REMARKS/ARGUMENT

I. OBJECTIONS TO THE DRAWINGS

AMENDMENT TO THE DRAWING(S)

FIG. 1 PRIOR ART

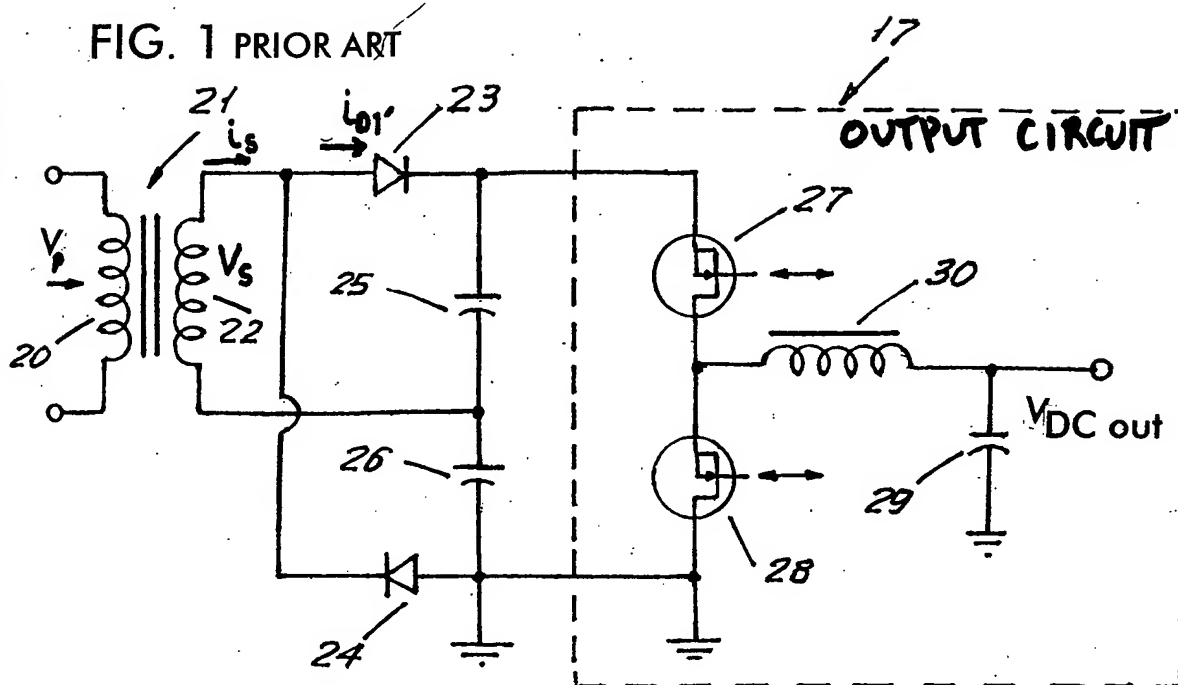
The Examiner also suggests labeling boxes 7 and 17 in Figures 2A and 1, respectively. Applicants have amended the Figures herein to make clear that reference numerals "7" and "17" both refer to respective output circuits.

FIG. 2A

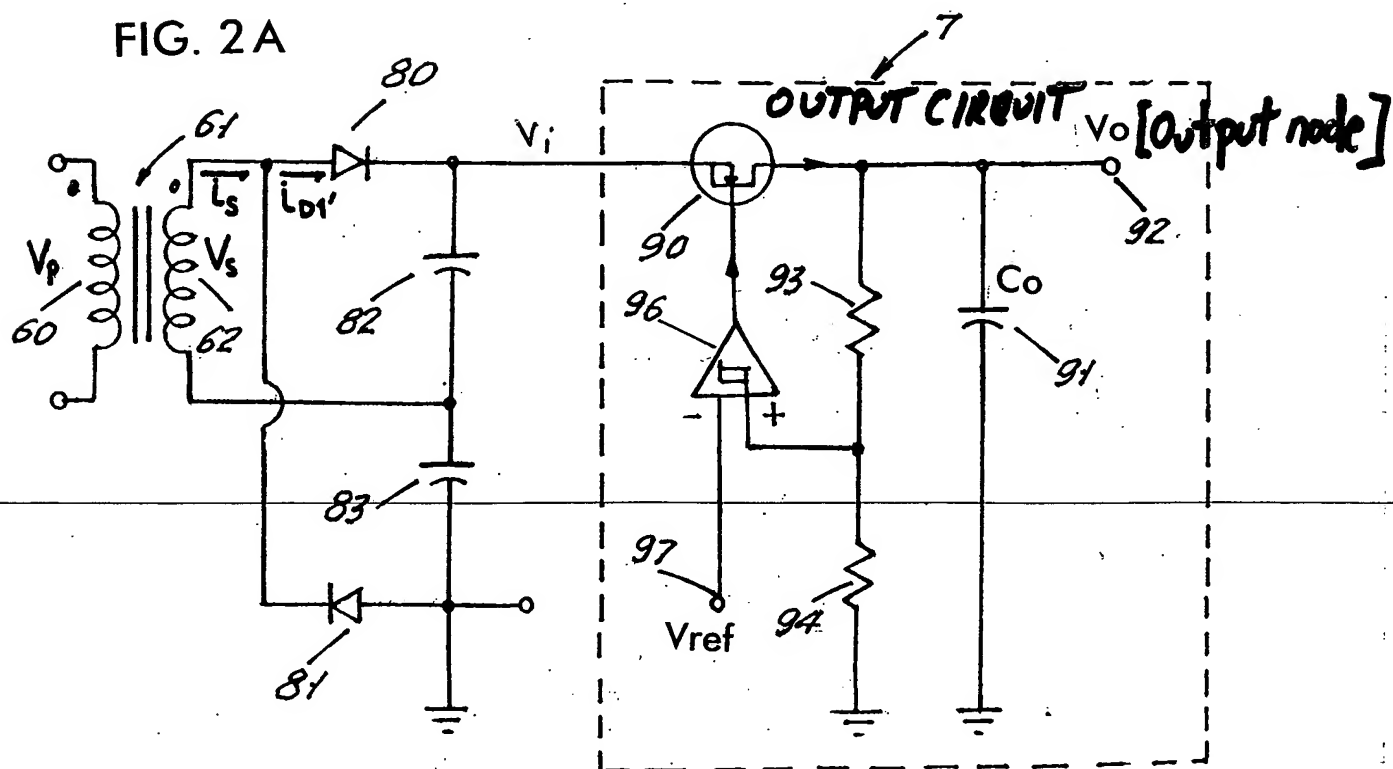
The Examiner also contends that it is unclear what V_i is in Figure 2A. V_i is the input to the output circuit 7.

The Examiner also contends that it is unclear which node is the "output node" in Figure 2A. Figure 2A has been amended herein to make clear that V_o is the output node.

FIG. 2B

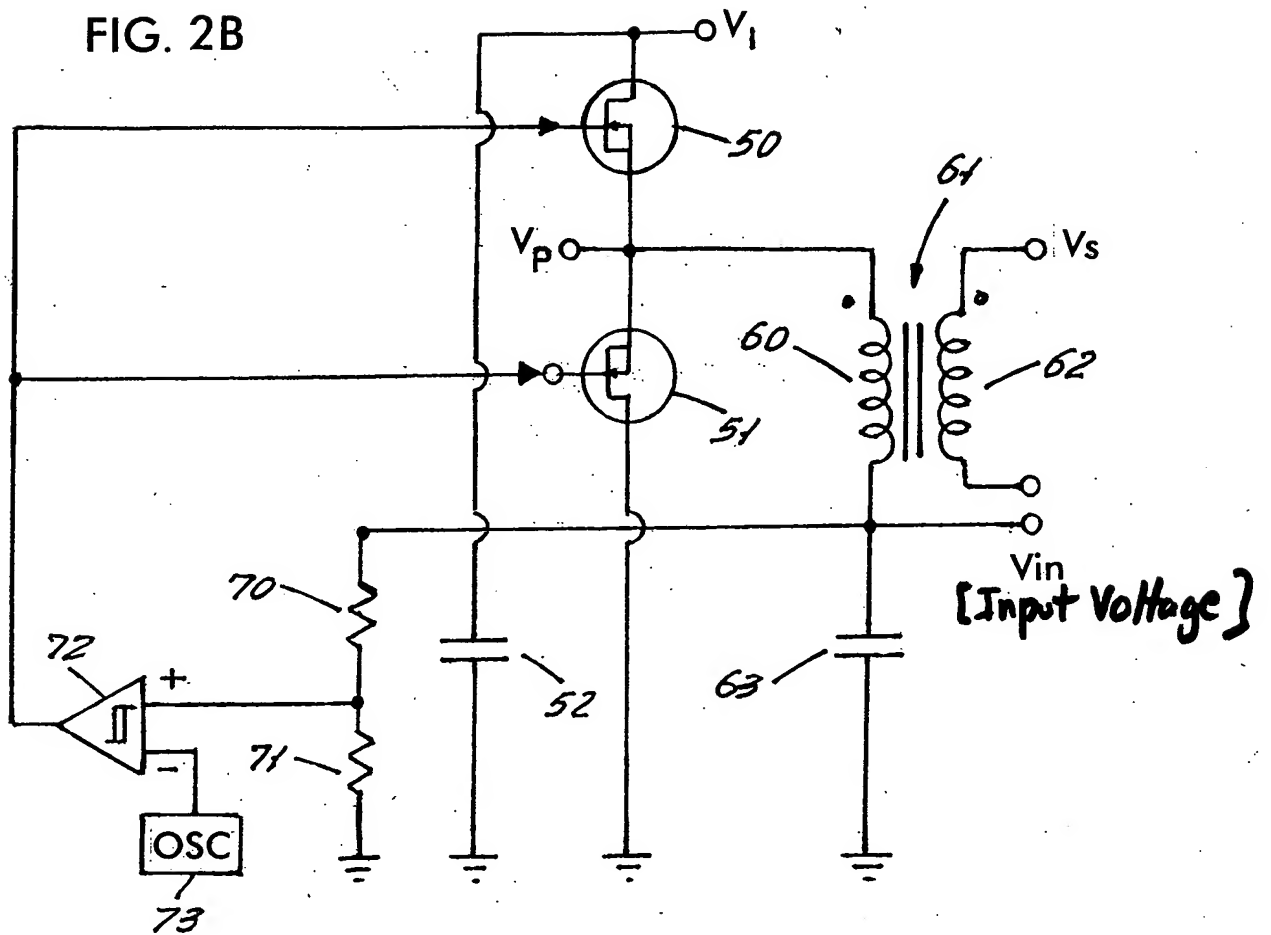
First, the Examiner contends that it is not clear where V_{IN} of Figures 2A and 2B is from. Applicants direct the Examiner to Figure 2B, which illustrates V_{IN} as an input voltage to the primary winding circuit. V_{IN} is neither an input nor an output to the circuit illustrated in Figure 2A. As described in paragraph [0023] of the Specification, V_{IN} is, in the illustrated embodiment, an input voltage connected to the opposite end of the primary winding 60 across capacitor 63 having a capacitance C2 and a resistor divider 70, 71. It is further described in paragraph 40. The duty cycle of the PWM modulator is proportional to V_{IN} . To eliminate any ambiguity, Figure 2B has been amended herein to make clear that V_{IN} is an input voltage.
